STATE OF WISCONSIN
DEPARTMENT OF TRANSPORTATION
PLAN OF PROPOSED IMPROVEMENT
STH 54 - PACKERLAND DRIVE
AIRPORT ENTRANCE & STH 54 INT
STH 172
BROWN COUNTY

STATE PROJECT NUMBER
9280-04-72

AS-BUILT PLAN

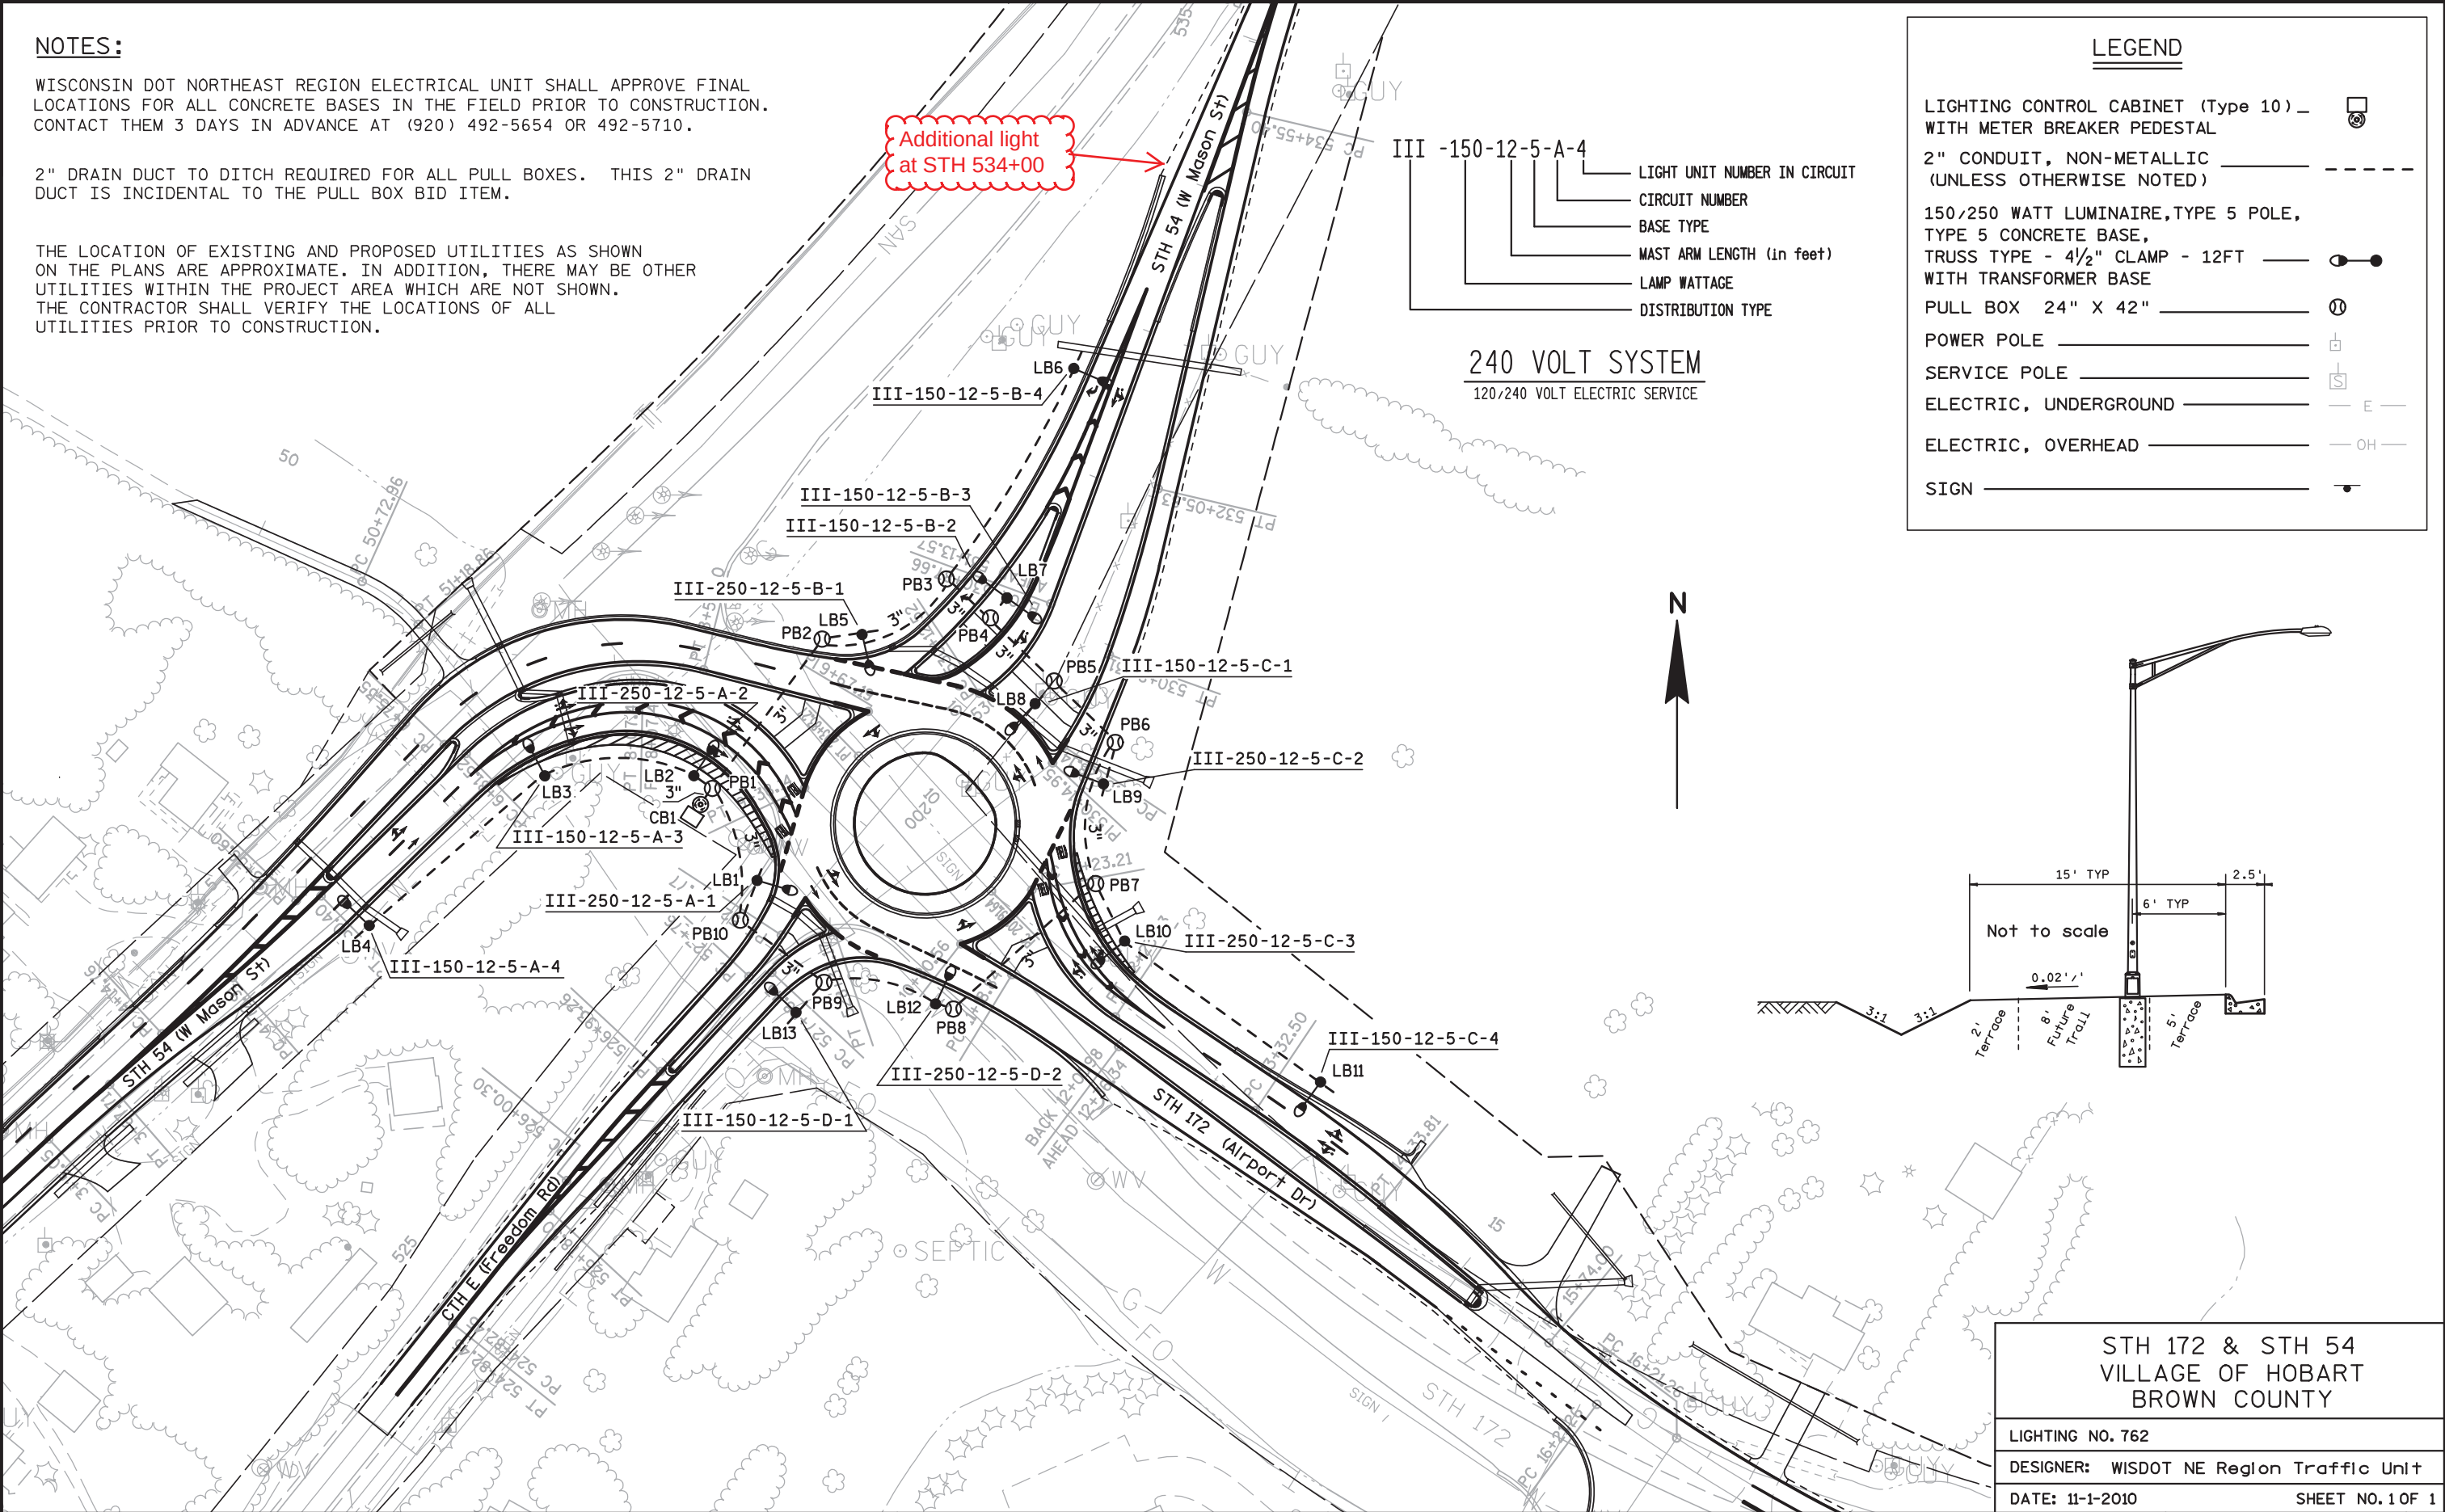
Additional light
at STH 534+00
